Corrigendum No. -03 Date:- 26.07.2021

Subject of the NIT:- OPEN TENDER ENQUIRY FOR "TENDER SPECIFIC STRATEGIC TIE-UP FOR "CONSTRUCTION OF 400 KV AND 220 KV TRANSMISSION LINE WORK (DETAILS AS BELOW) INCLUDING SUPPLY OF ALL EQUIPMENT/MATERIALS, ERECTION (INCLUDING CIVIL WORKS), ARRANGEMENT / SETTLEMENT OF RIGHT OF WAY, TESTING & COMMISSIONING ON EPC BASIS" FOR M/S RRPVNL AT PACHPADRA IN RAJASTHAN.

PRE BID CLARIFICATION

Sub :- Construction of 400/220KV GSS Pachpadra along with 500MVA 400/220/33 KV Transformer and 400 KV, 125MVAR Bus Reactor Including Supply of All Equipments/Materials, Erection (Including Civil Works), Testing and Commissioning (on Turnkey Basis) and associated 400KV & 220KV Transmission Lines Under Bid No.: BN-9019002102, (UBN- VPN2122WLOB00193).

SINGLE LINE DIAGRAM OF 400/220 KV GSS PACHPADA (BARMER)

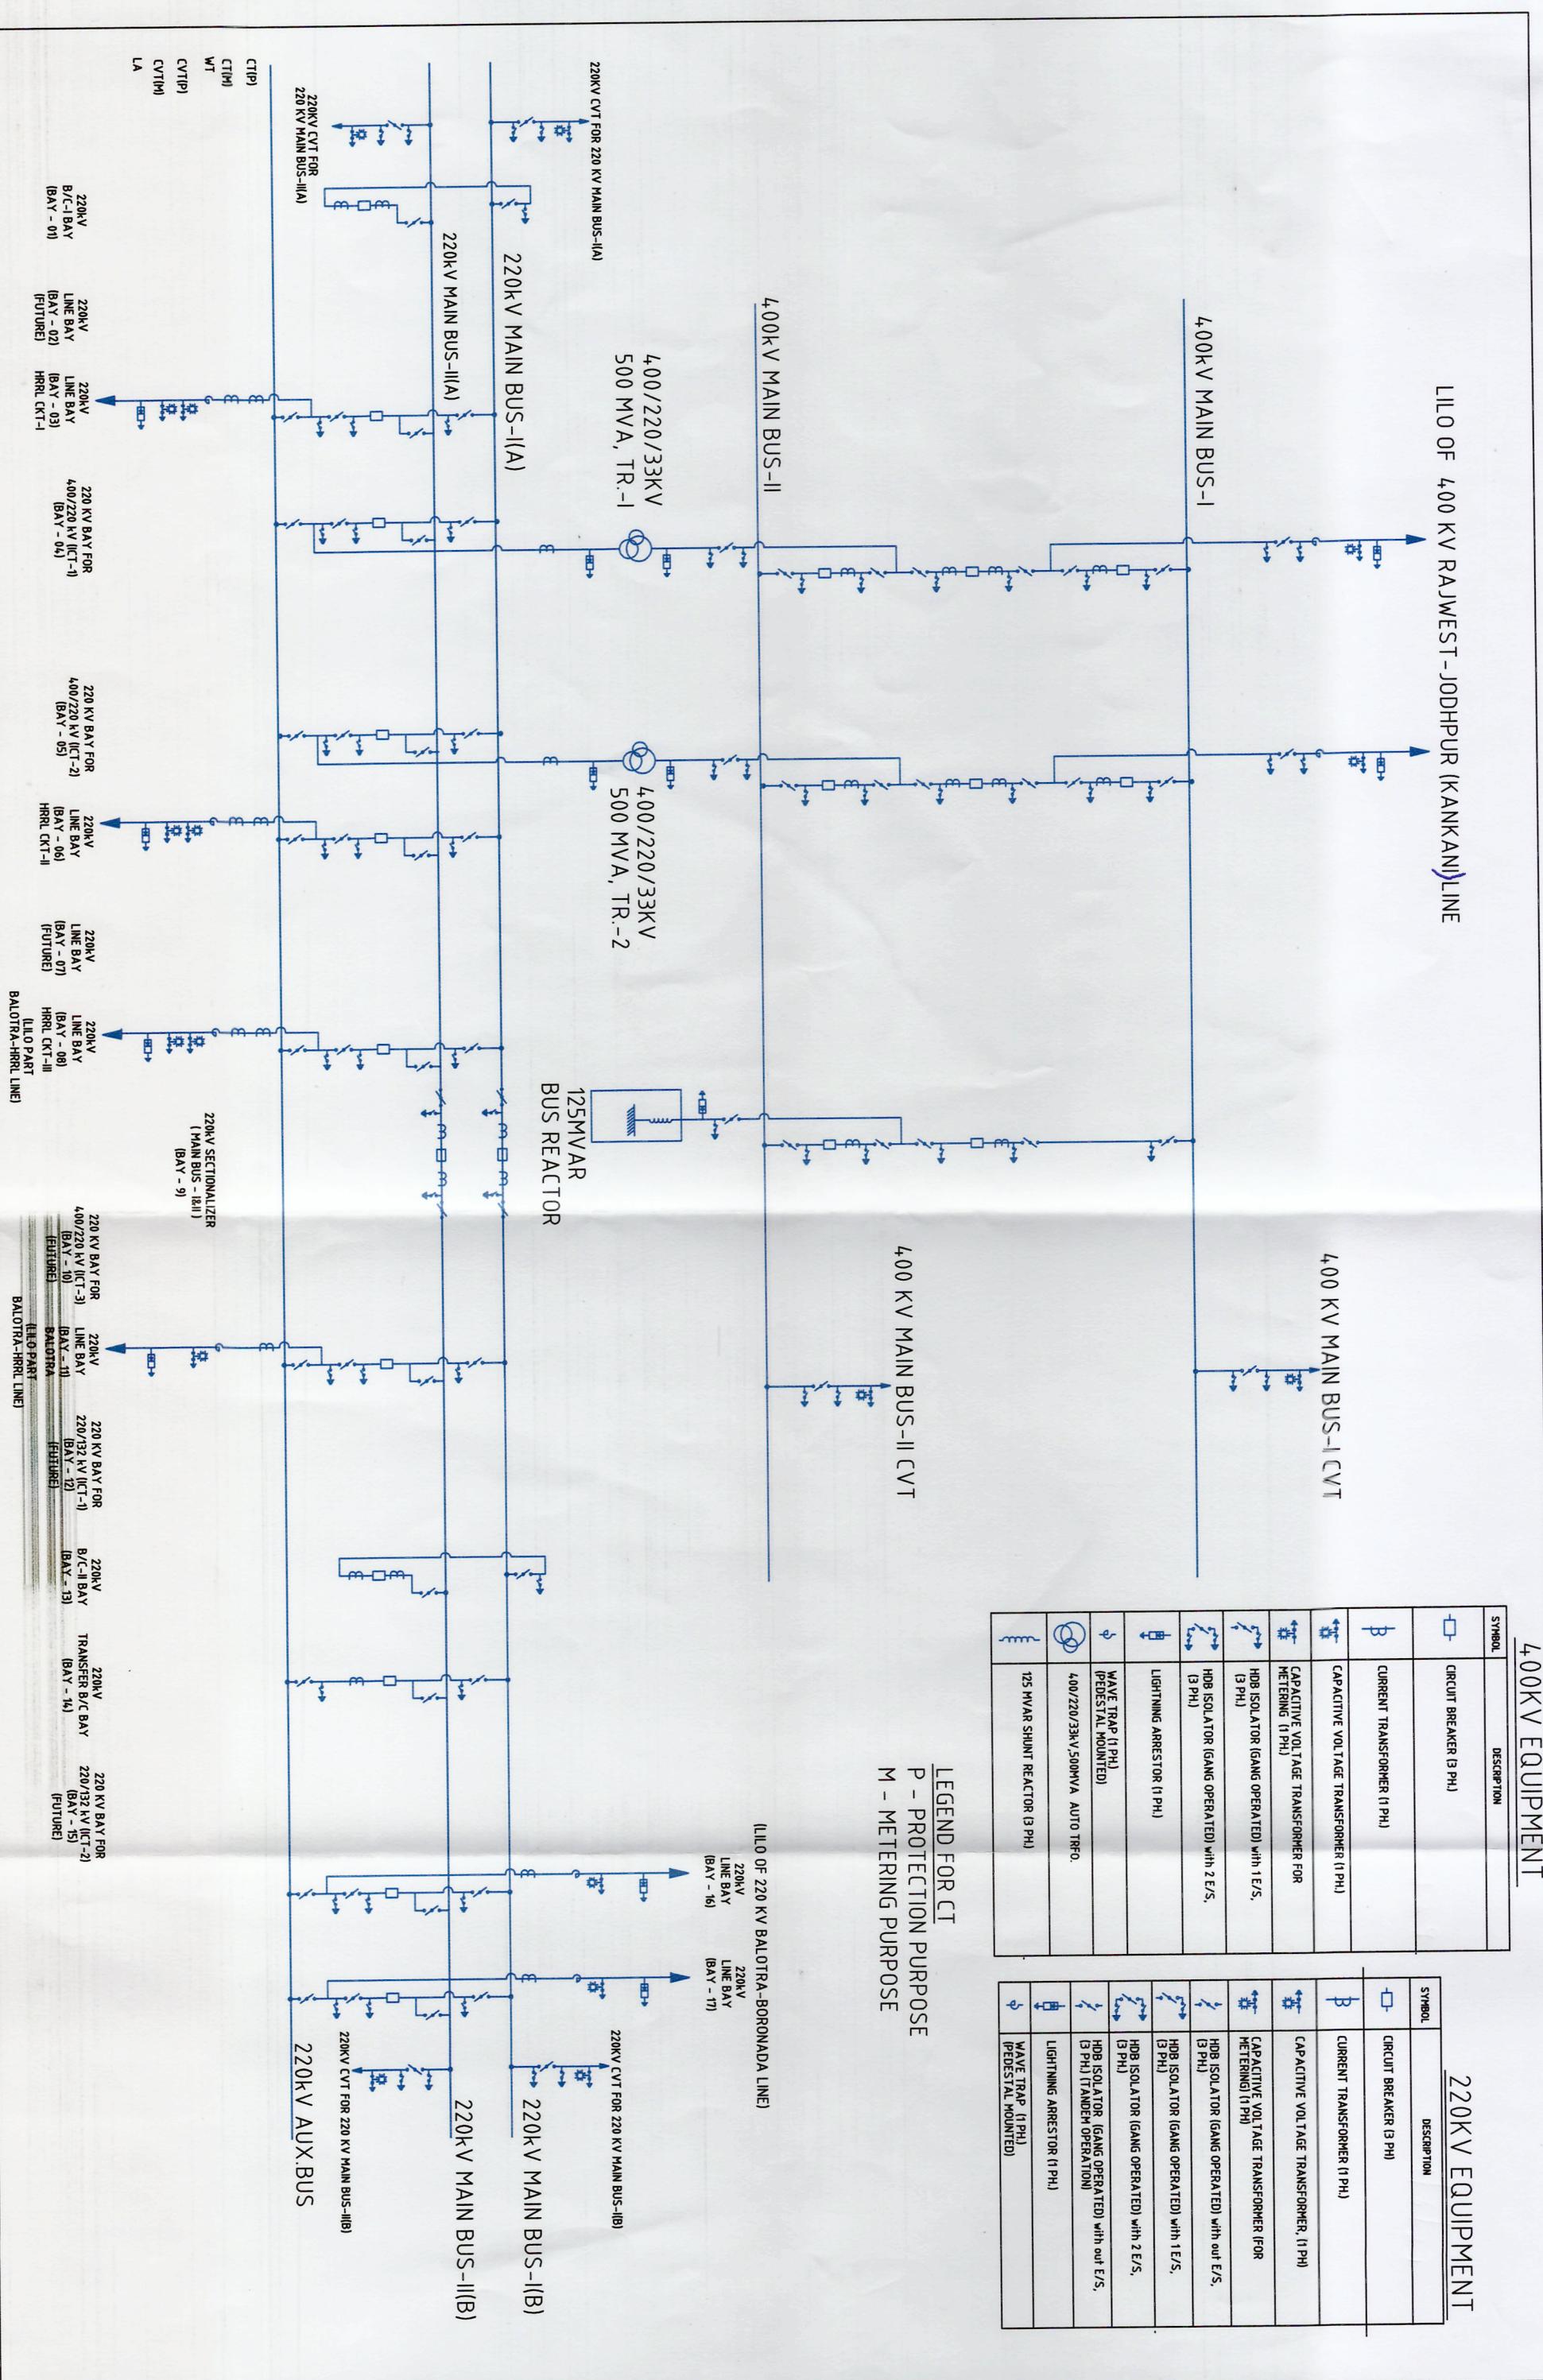
3	Drawings	400/220KV GSS PachpadraSLD	In given tender document there is no SLD attached in "Drawings " It is requested to provide the 400/220KV GSS Pachpadra- SLD for better understanding.	SLD Enclosed.
4	Drawings	400/220KV GSS- Section Layout	<p>In BPS some of the line items are estimate (i.e Insulator hardware, BPI's ,Insulators ,Clamps etc) by BIDDER however given "400/220KV GSS" Section's is not clear for understanding the design .It is requested to furnish the clear PDF /CAD drawing for better to estimate the LOT items.</p> <p>In given tender document there is no SECTION LAYOUT for 220KV in "Drawings " It is requested to furnish the clear PDF /CAD drawing for better to estimate the LOT items.</p>	<p>Section drawing for 400 KV & 220 KV Enclosed.(for tender purpose only)</p>

82	Drawings	Single Line Diagram	i) Please provide Single Line Diagram of subject tender. ii) We understand that main busbar current rating of subject project is 2000A - please confirm. iii) We understand that short circuit level of subject substation is 40kA for 1 sec for both 400kV & 220kV S/S - please confirm. iv) Please provide section drawing of 220kV switchyard. v) Please provide electrical layout superimposed on contour layout for subject project. vi) Please provide structural layout of subject project.	i) Attached ii) 2000A iii) 40kA for 1 sec iv) Attached v) Attached. vi) ELP Enclosed
83	VOL_II_GSS 'Part – 1 General Specification Part – 3 (Sec-II) Substation Automation System	The bidder is required to indicate training charges lump sum in the price schedule to be carried out at Manufacturer's Works in India / abroad for the training mentioned above which shall be considered for price bid evaluation. These charges should include: To and Fro Air Ticket, Training, accommodation (boarding & lodging), food, local transport etc For all training courses, the travel (e.g. airfare) and per-diem expenses will be borne by the participants.	i) Request M/s. RRPVNL to take care of "To and Fro Air Ticket, Training, accommodation (boarding & lodging), food, local transport" of RRPVNL personnel for training purpose - please confirm. ii) Discrepancy observed between referred clauses regarding travel (airfare) - please clarify.	To and Fro Air Ticket, Training, accommodation (boarding & lodging), food, local transport etc will be in the scope of Bidder.

42	BOQ 399710	BoQ-1, SL no. 66, 112, 115, 118, 121	The quantity of 220kV CT & isolators are not matching w.r.t the number of 220kV bays. To understand the requirement better, we request RVPN to furnish the SLD for 400/220kV substation with proper legends.	SLD Enclosed.
43	BOQ 399710	BoQ-1, SL no.71, 245 kV single phase two core current transformers for	As per referred clause, 245kV Metering current transformer & metering CVT quantity are mentioned. In this regard, please clarify for which 245kV line bays, metering CT & CVT shall	SLD Enclosed.
